Informal document N° 14
(28th GRSP, 27 Nov.- 1 Dec. 2000
agenda item 2.4)

**OICA PROPOSAL FOR AMENDMENTS TO ECE REGULATION N° 21
REGARDING POWER OPERATED WINDOWS,
OPENING ROOFS AND PARTITIONS**

FIGURE 1

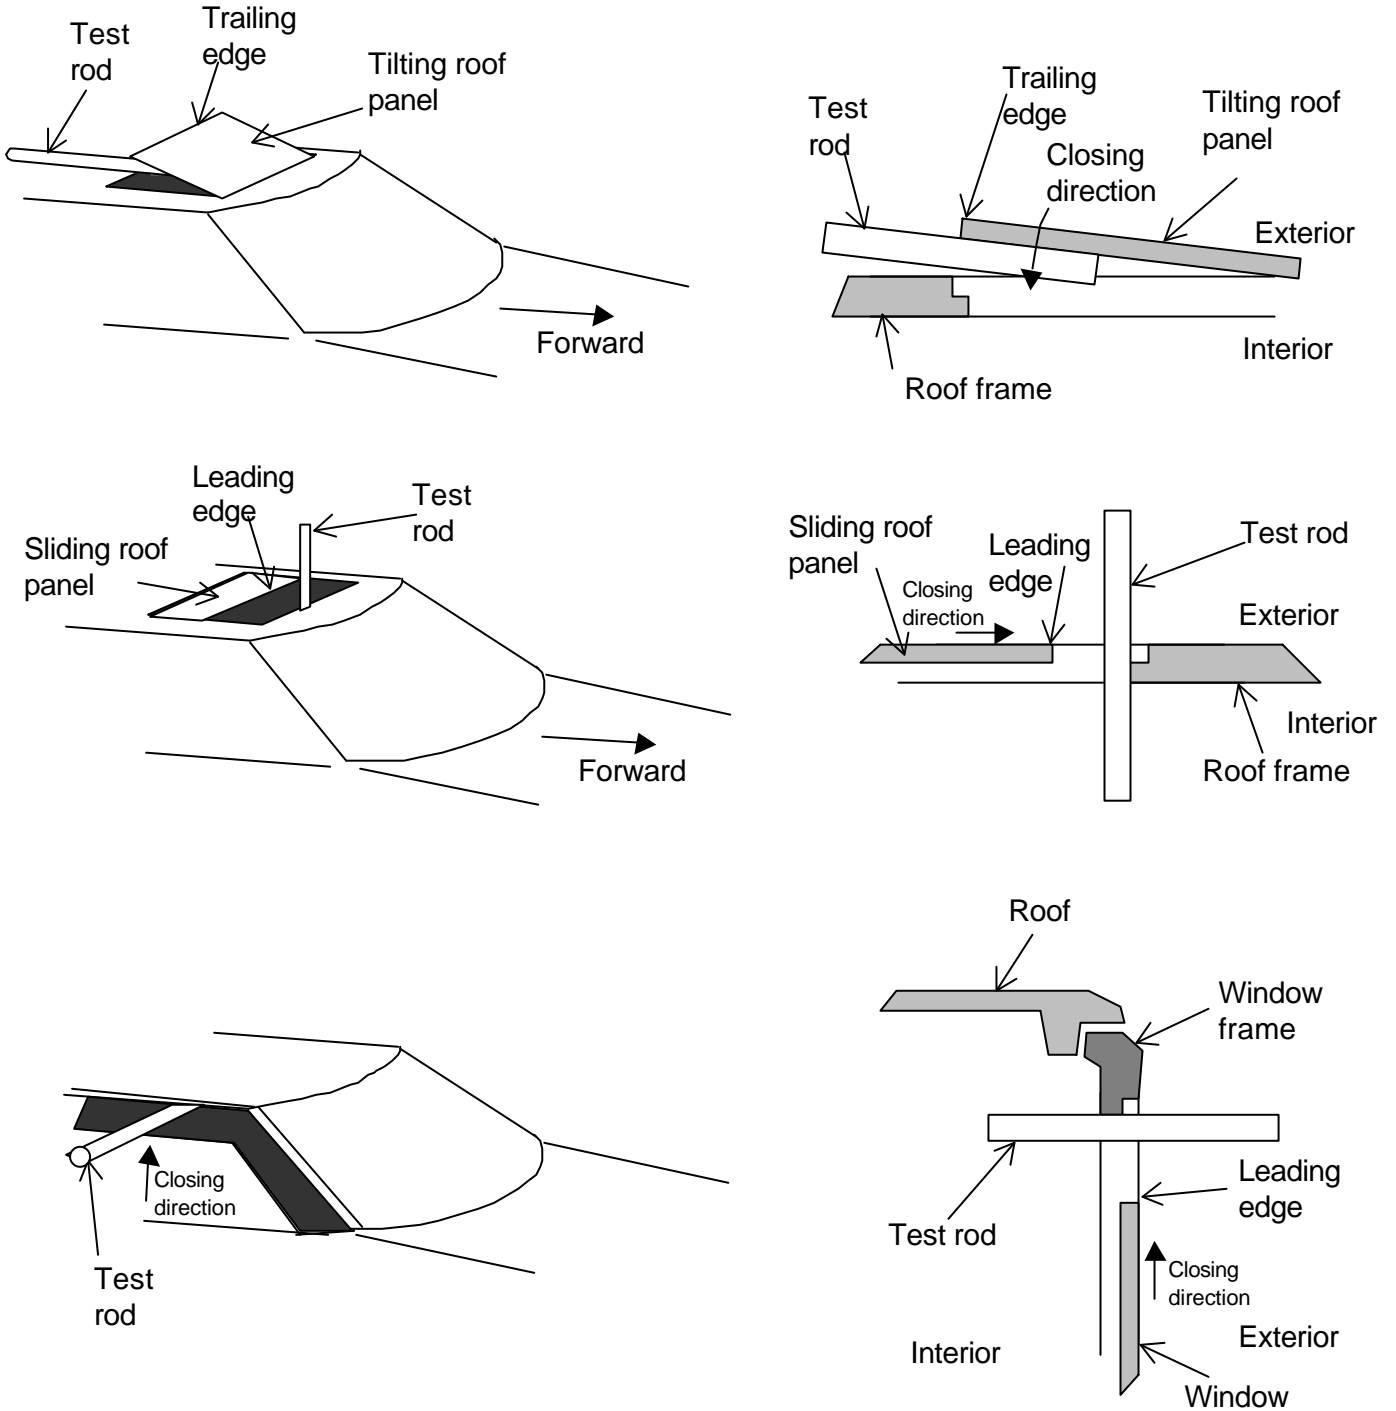
To measure an opening, a cylindrical test rod shall (without exerting force) be placed through it ~~normally perpendicular to the edge and perpendicular to the closing direction of the window, roof panel or partition and perpendicular~~ to the edge of the window, roof panel or partition and perpendicular to its closing direction as shown in Annex 9, Figure 1, from the interior up to the exterior of the vehicle or, as applicable, from the rear part of the passenger compartment.

5.8.3.3. To check power-operated windows / roof-panel systems / partition systems with reversing devices, a measuring instrument / test rod shall be placed through the opening **from the inside of the vehicle perpendicular to the edge of the window / roof panel / partition and perpendicular to its closing direction as shown in Annex 9, Figure 1, from the interior up to the exterior of the vehicle** or, in the case of a partition system, from the rear part of the passenger compartment, in such a way that the cylindrical surface of the rod contacts any part of the vehicle structure which forms the boundary of the window / roof-panel / partition aperture. The force deflection ratio of the measuring instrument shall be $10 \pm 0.5 \text{ N/mm}$ **with a tolerance of max. 1 N/mm**. The positions of the test rods (**normally** located perpendicular to the window / roof panel / partition edge and perpendicular to the closing direction) are illustrated in Annex 9, Figure 1. **The relative position of the test rod shall be kept during the test. The position of the test rod relative to the edge and the closing direction shall be kept throughout the test.**

FIGURE 2

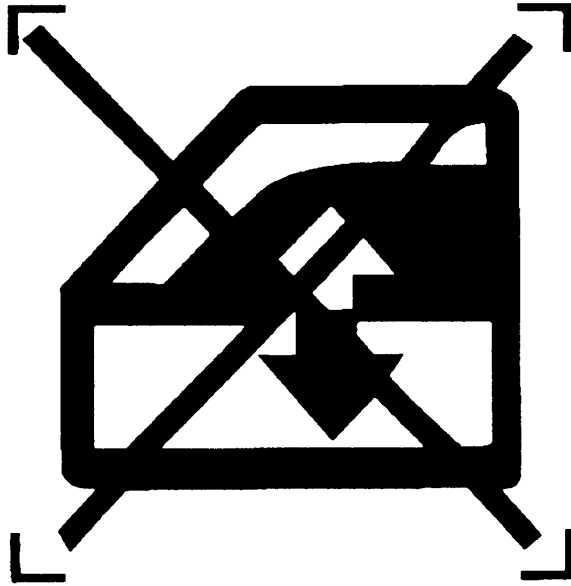
The driver-controlled switch shall be located so as to minimise any accidental manipulating. It shall be identified by the symbol shown in Annex 9, Figure 2 **Appendix 4** or an equivalent labelling, for example according to ISO 2575:1998 **also reproduced in Annex 9, figure 3.**
